# PORTLAND PUBLIC SCHOOLS – FACILITY ADA ASSESSMENT

Clarendon-Portsmouth School      K-8  
 August 31, 2009

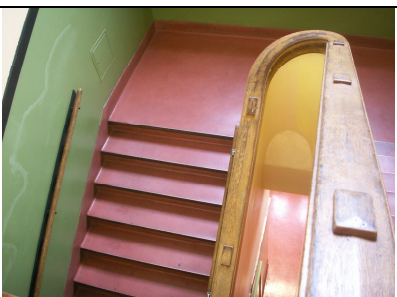
Parking	Three ADA spaces exist at the west parking lot. Repair sign at van accessible space. Verify that the stall width is 9-feet with an 8-foot striped aisle.	
West (Parking) Entry	West doorway is an accessible entry and marked with signage.	See picture above.
Front South Entry Accessible Path	Existing concrete stairs, ramp and handrails at building main doorway are compliant for adult reach range.
